Origination Form
Proposed Revisions to a Standard Plans Index

Originator:	Turley, Joshua	Index Number:	102-201
Date:	6/17/2025	Sheet Number(s):	1-5
E-mail:	Joshua.Turley@dot.state.fl.us	Index Title:	Temporary Acrow 700XS Series Detour Bridge General Notes and Details

TEMPORARY ACROW 700XS SERIES DETOUR BRIDGE
GENERAL NOTE AND DETAILS

INDEX
102-201

NOTE:

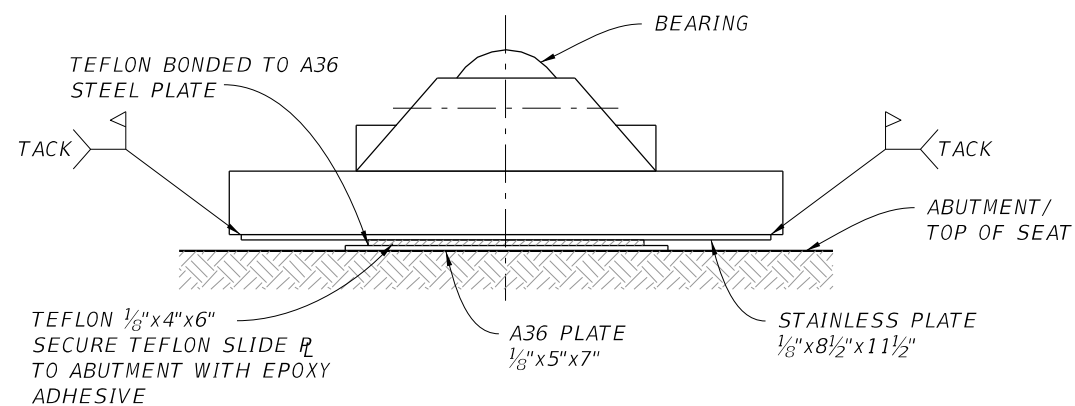
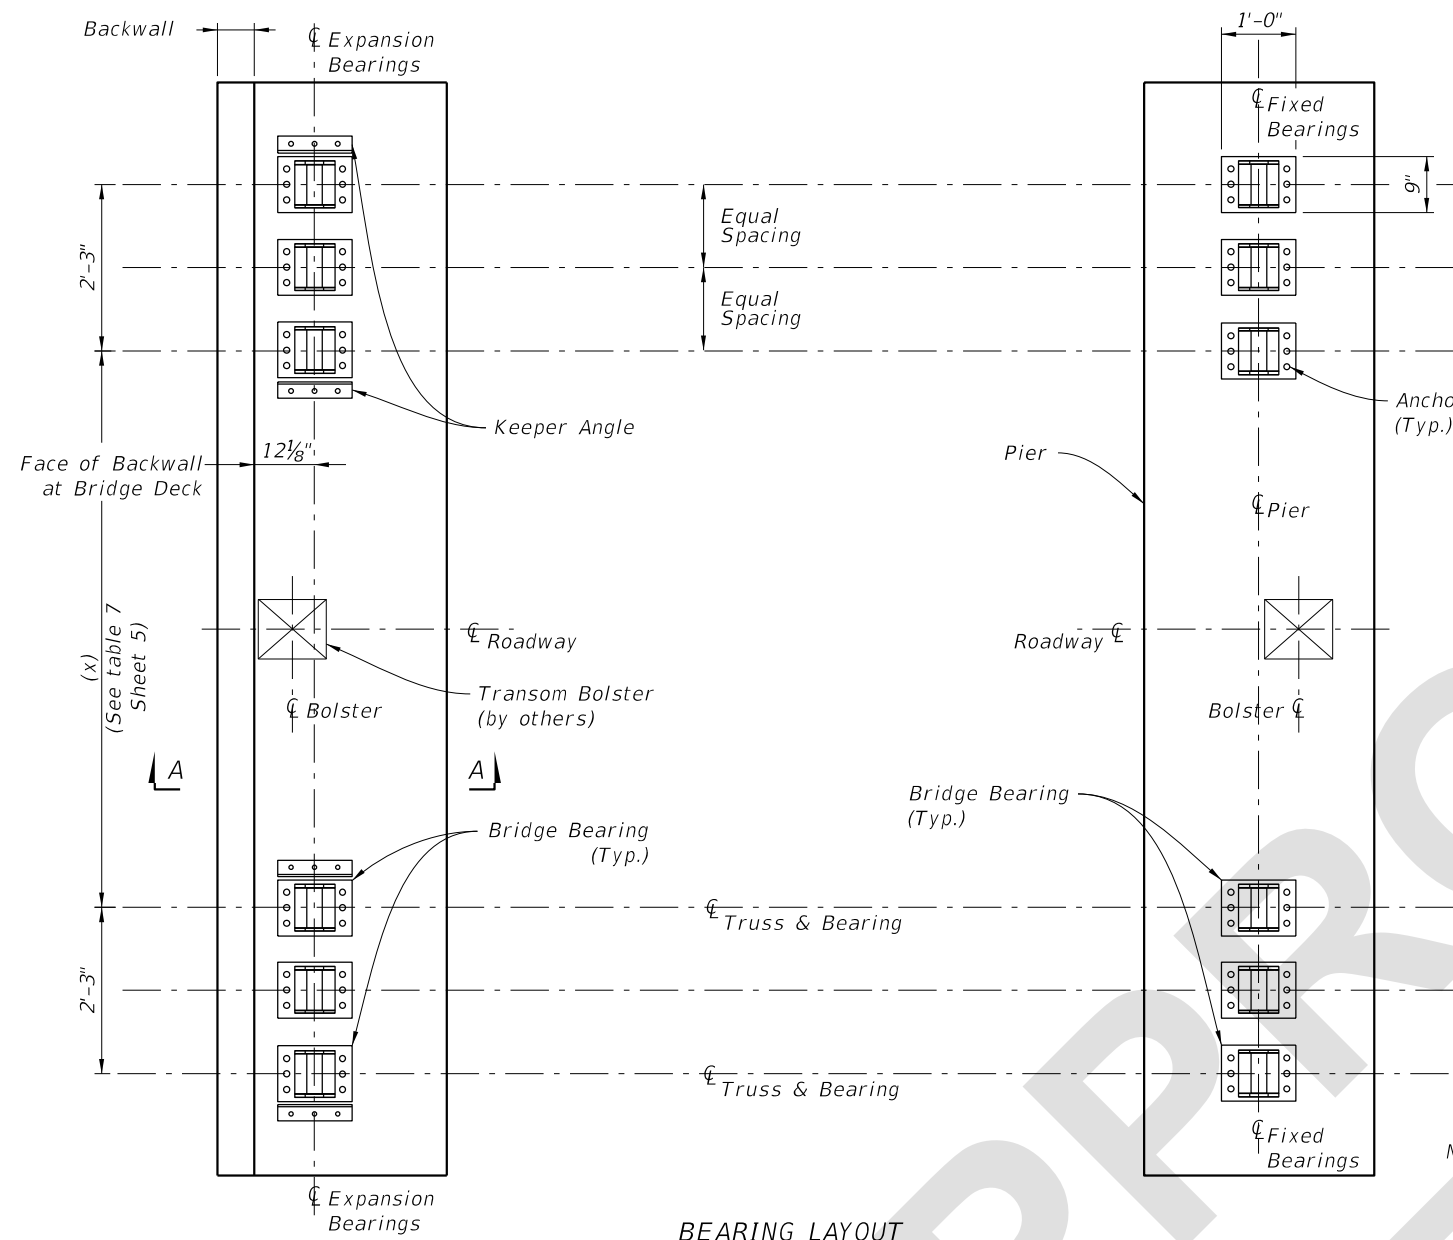
Sheet 4: Updated BOLSTER DETAIL with new detail provided by ACROW

- HARDWOOD BLOCKING IS RECOMMENDED; SEE PLAN FOR FINAL BOLSTER DESIGN.
- INSTALL BOLSTER TO A TIGHT FIT AFTER BRIDGE & DECK ARE IN PLACE.
- BOLSTER HEIGHT WILL VARY BASED ON TRANSOM TYPE/ DEAD LOADS.
- BOLSTER TO BE SECURED FROM MOVEMENT AFTER INSTALLATION.
- BOLSTER TO MATCH SLOPE OR TRANSOM FLANGE.

1. Hardwood Blocking is recommended; See Plan for final Bolster Design.
2. Install Bolster to a tight fit after Bridge & Deck are in place.
3. Bolster height will vary based on Transom Type/ Dead Loads.
4. Bolster to be secured from movement after installation.
5. Bolster to match Slope or Transom Flange.
